Hapeville
georgia

DESIGN REVIEW COMMITTEE

November 20, 2024 6:00 PM

AGENDA

Maple Street

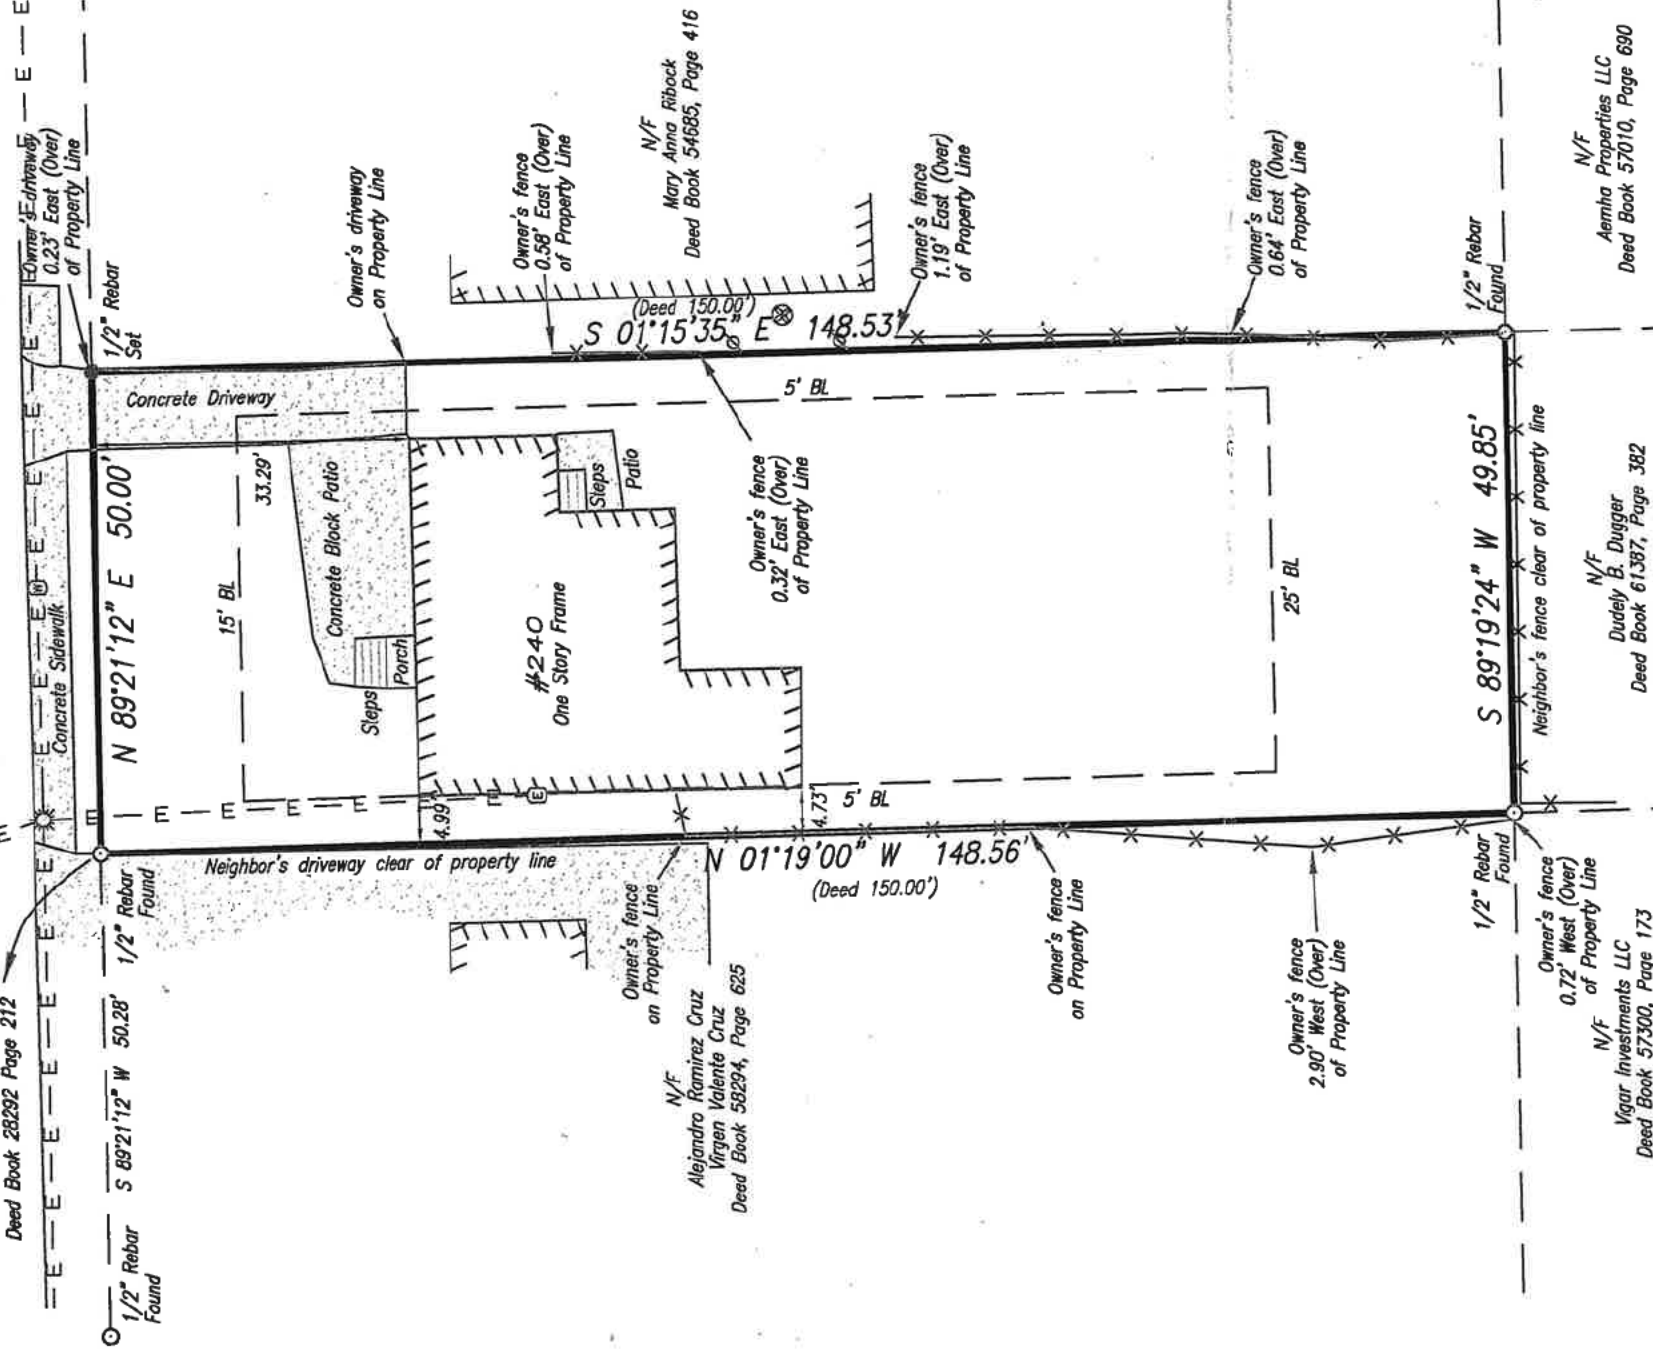
STAFF COMMENT: The proposed detached garage is to be located 15' from the east property line. The rear setback has not been provided nor has distance from the dwelling to the garage. It is estimated the distance will be 10' from the house and 35' from the rear property line but this should be confirmed.

Provide the distance of the garage from the dwelling.

Provide the square footage of the dwelling to ensure the distance requirement is met.

CAD DWG FILE: 613 SPRING STREET-ADU-A1 ELEVATIONS.DWG

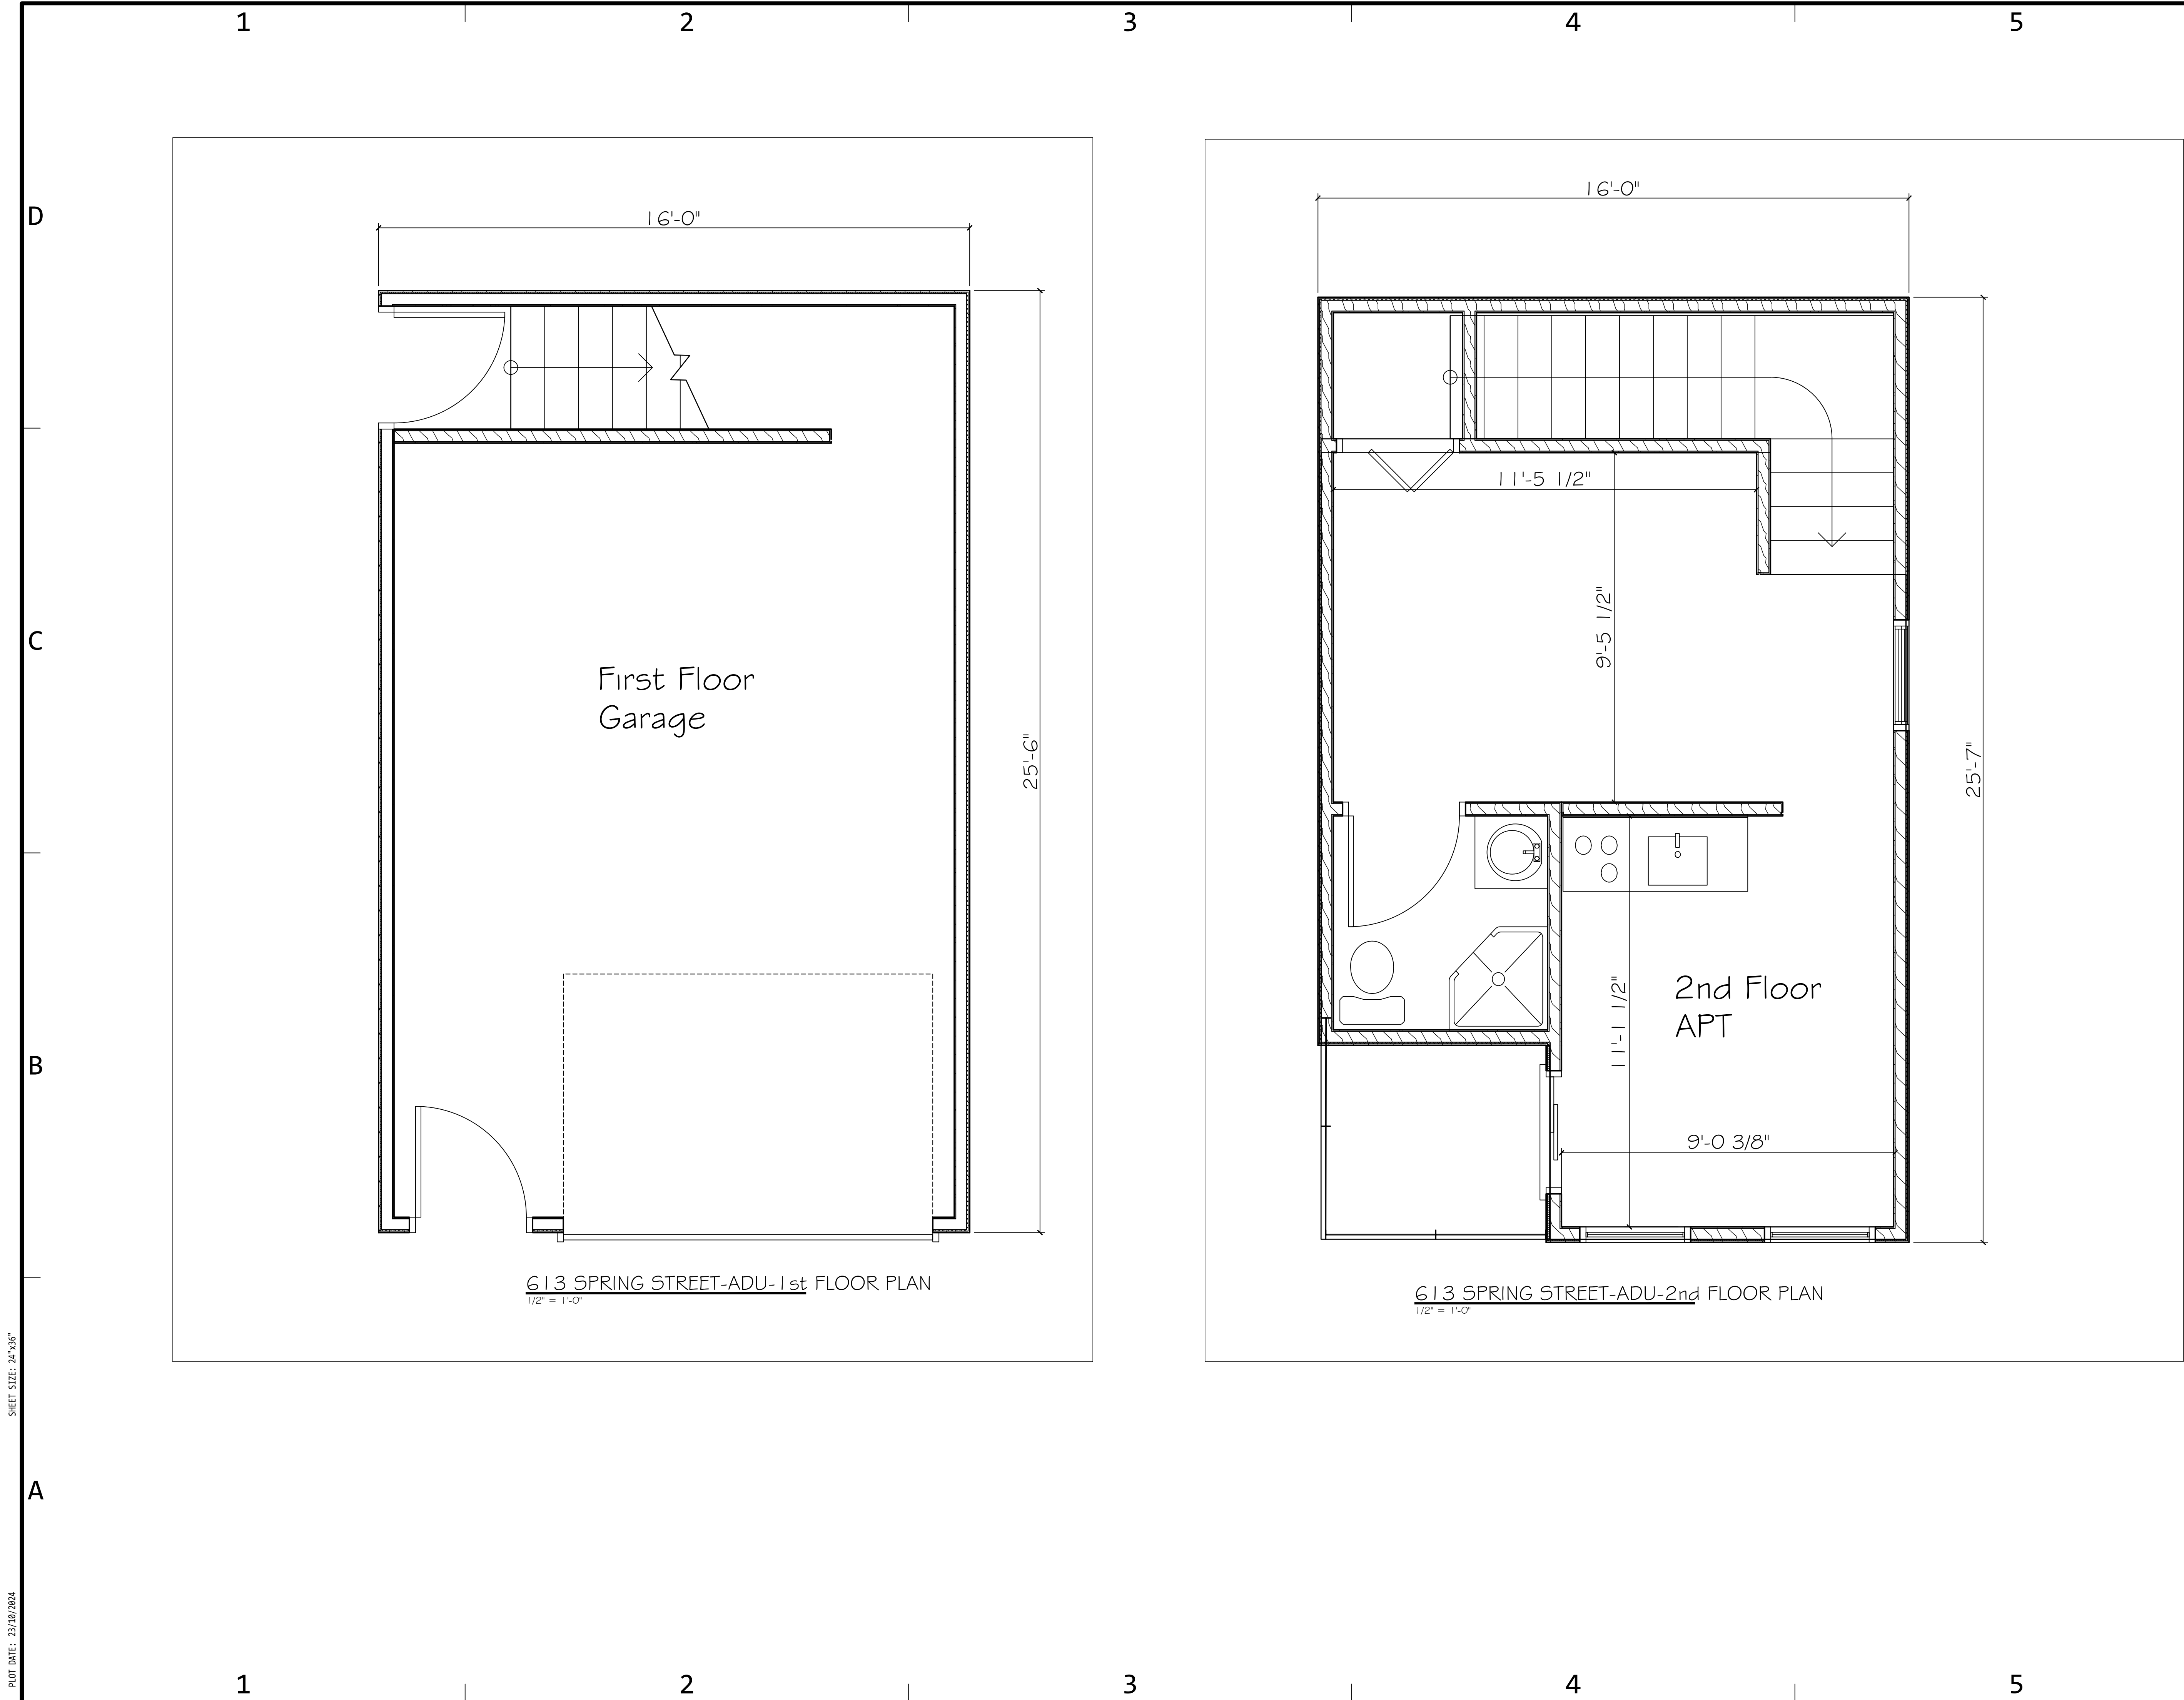
- A light at the front door should be shown on the plans and installed.
- Roof Shingles should have a 30 year warranty. Please call out on plans.
- Roof overhang dimension should be provided. Unless matching existing (with approved Design Exception), overhangs should be 1'.

- Building number should be shown on plans
- Window recess of at least 2" should be shown on plans.
- Fenestration percentage calculation should be provided.

- Distinct sills are shown on the elevations but no detail provided for material. Please identify and ensure installation.
- Verify the painting or staining of the porch.
- No railing is shown on front (confirm if no railing is required) and proposed railing in rear is horizontal versus prescribed standard, Design Exception is recommended.
- The porch columns end on the concrete porch steps, Design Exception is recommended.
- Porch width and depth dimensions should be provided. If standards are not met (80% of façade and 8' in depth) aren't met, Design Exception may be recommended.
- Distance between porch columns should be provided. If greater than 8', Design Exception may be recommended.
- Distance of ADU from any structures on adjacent property should be shown. It is a zoning requirement that it be at least 10' wall to wall.
